construction bid document addendum 01

project: Southern Maine Community College - Horticulture Greenhouse
Midcoast Campus, Brunswick, Maine BGS # 3674

date: 12 November 2024

SOUTH
199 prospect street, suite A
portland, maine 04101
NORTH
22 balsam drive
Millinocket, maine 04462
PH: 207.347.5252 & 207.749.9306
arcadiadesignworks.com

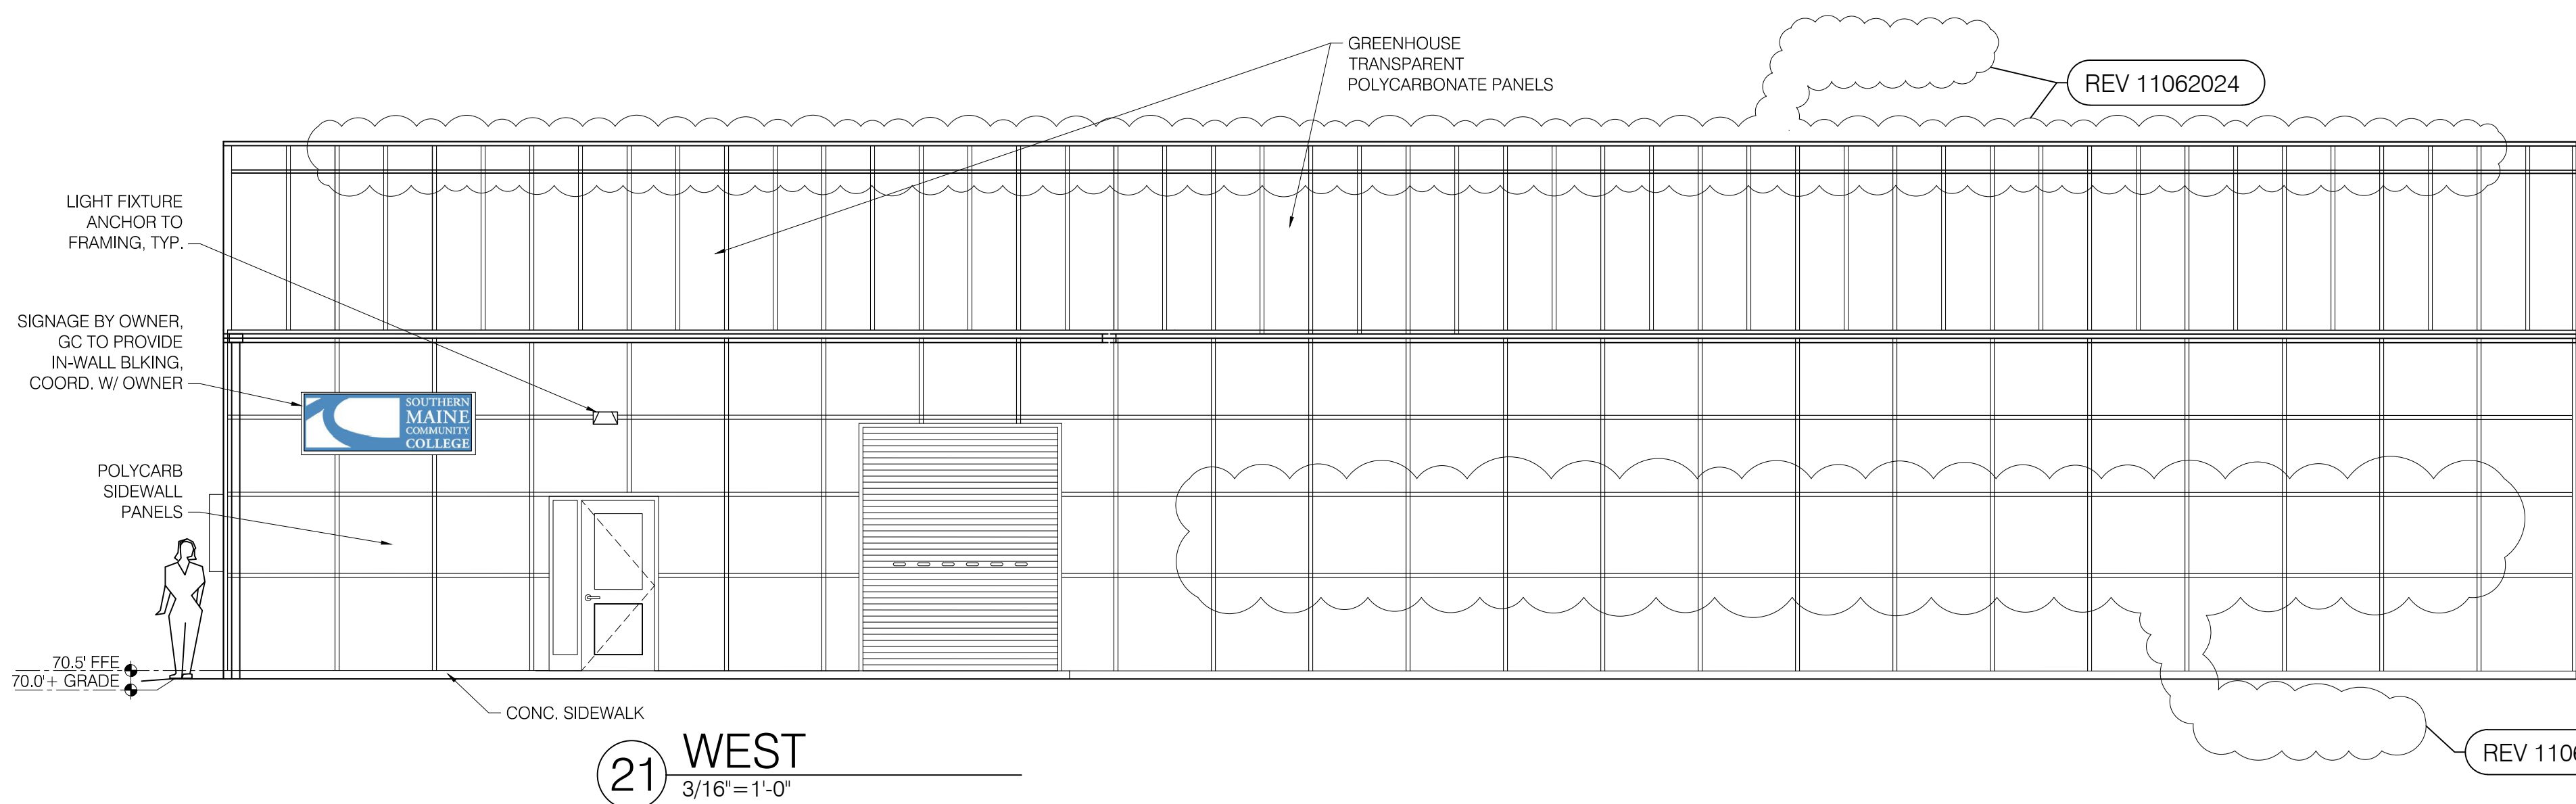
9. **Ventilation system.** Revisions as follows and as noted on attached drawings.
OMIT: West side of motorized gull-wing ridge vent. Maintain east side of motorized ridge vent on both bays.
OMIT: Manually operated wall ventilation.
OMIT: South elevation upper exhaust fans. Maintain (2) two lower exhaust fans on both bays per Greenhouse manufacturers sizing and specifications.
OMIT: North elevation upper intake dampers. Maintain (2) two lower intake dampers on both bays per Greenhouse manufacturers sizing and specifications.

A20 EXTERIOR ELEVATIONS: Wall ventilation removed, ridge ventilation revised and exhaust fans and dampers revised.
